25-115

1517 14th Ave NW Single-family Demo & Rebuild

Recommendation: CAPROC

**Subject:** Variance Request for 1517 14th Ave NW Single-family Demo & Rebuild, RCWD #25-115

1517 14TH AVENUE NW  
NEW BRIGHTON, MINNESOTA  
**CERTIFICATE OF SURVEY**  
FOR  
**ROBERT THOMAS HOMES, INC.**  
16972 BRANDT JEN FARM DRIVE LAKEVILLE, MN 55044

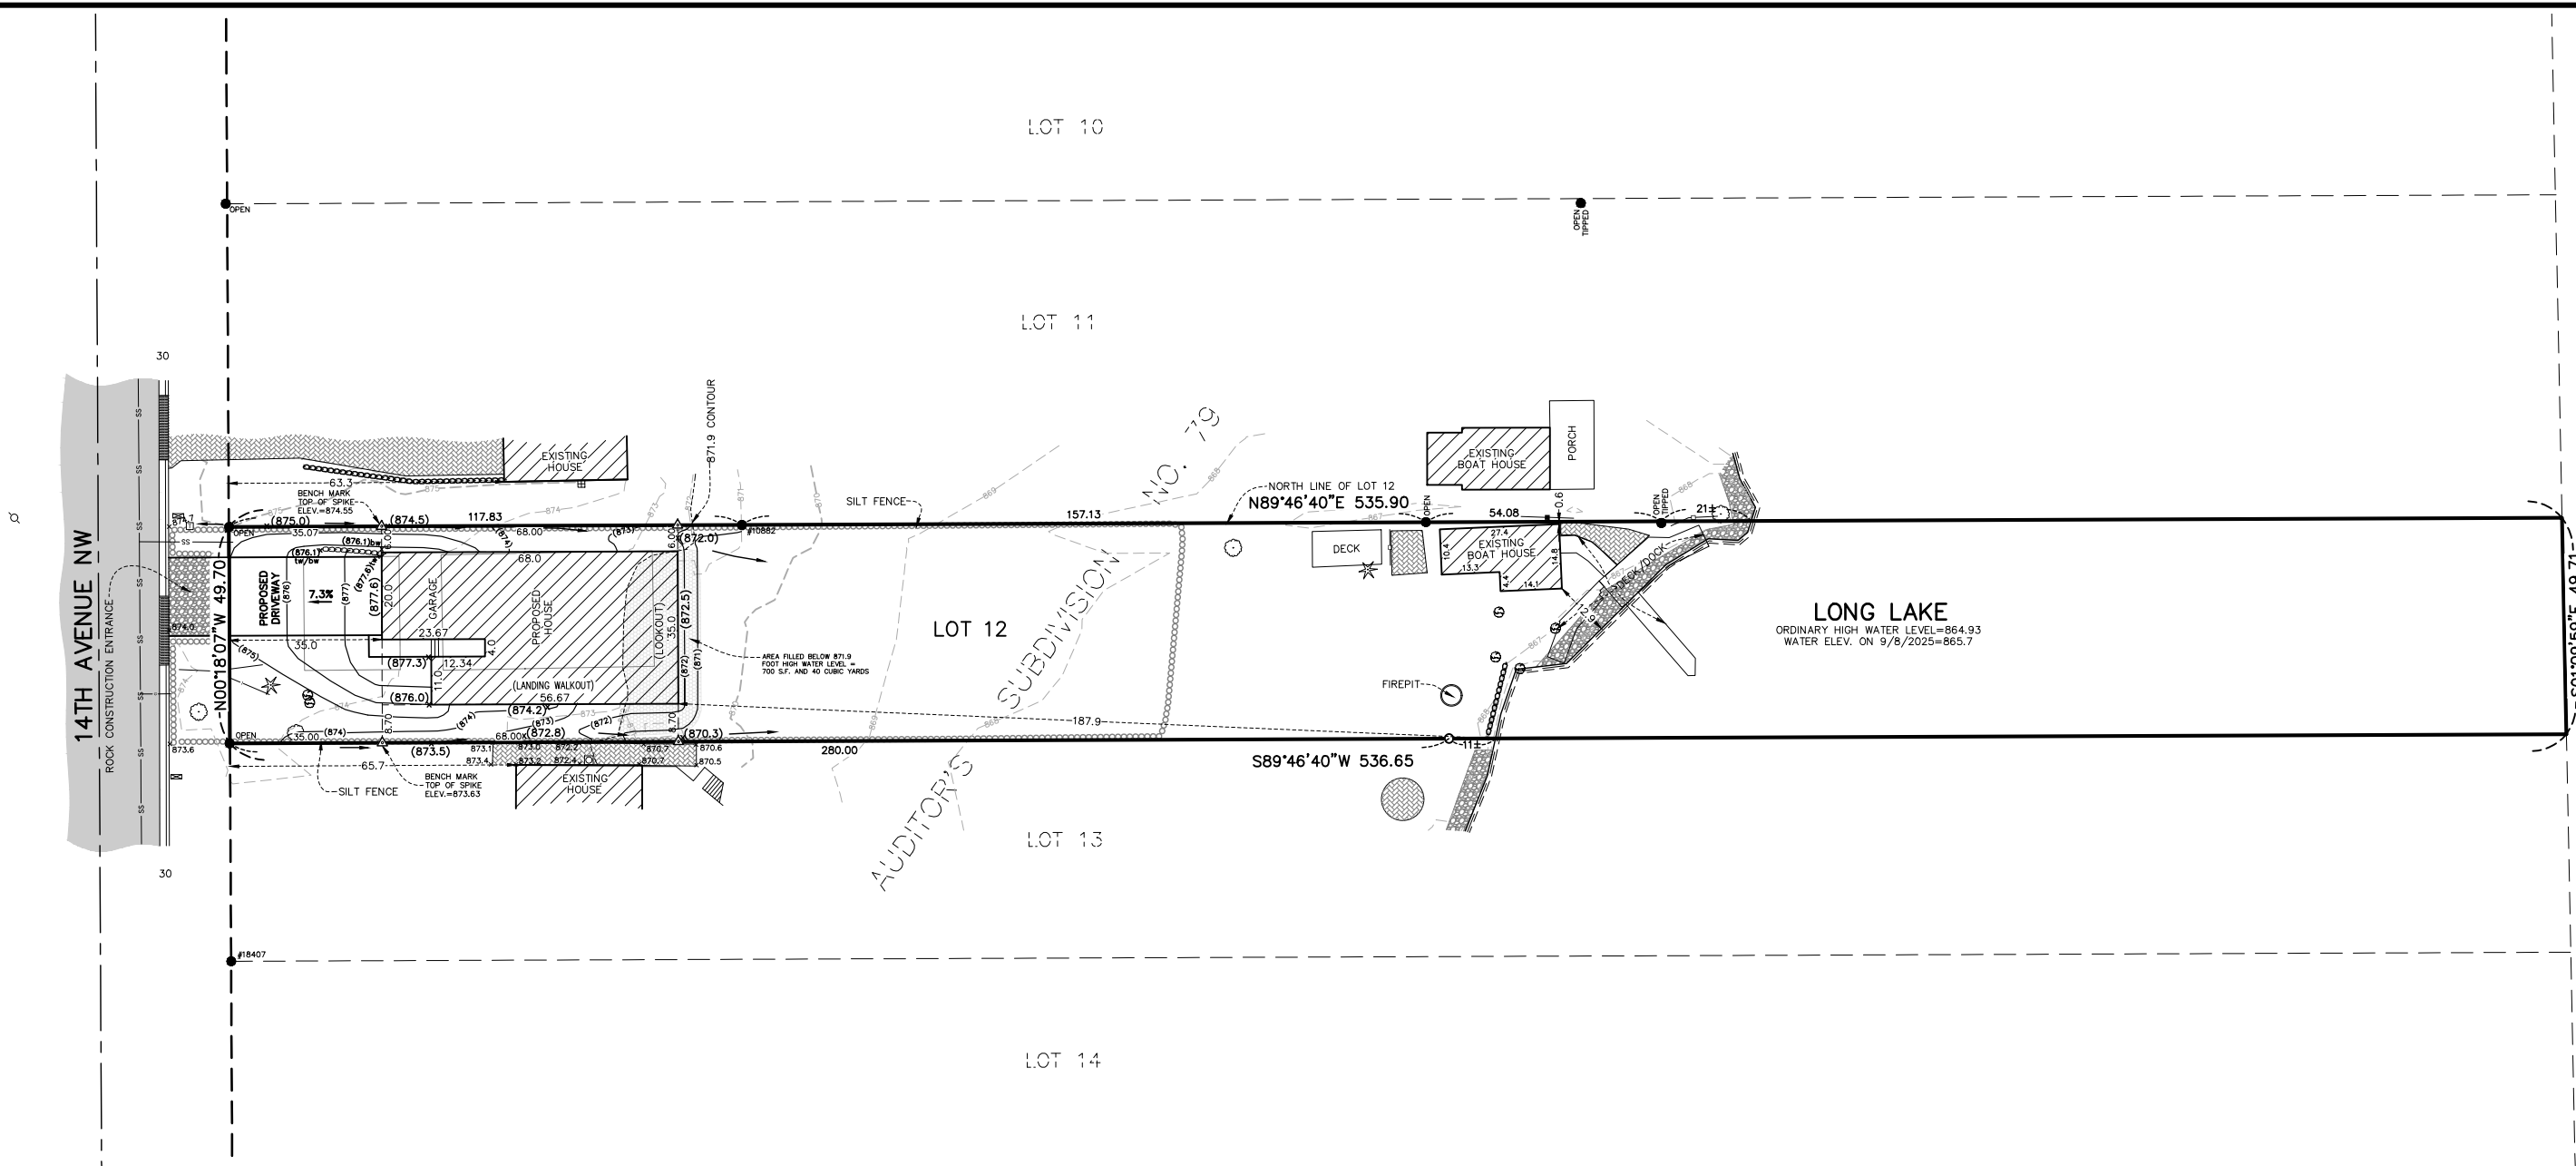
- It appears from inspection reports that the existing boat house has been removed. The Proposed Certificate of Survey should be updated.
4. The applicant is responsible for the actual cost of variance review and must pay any remaining balance due; contact District for amount.
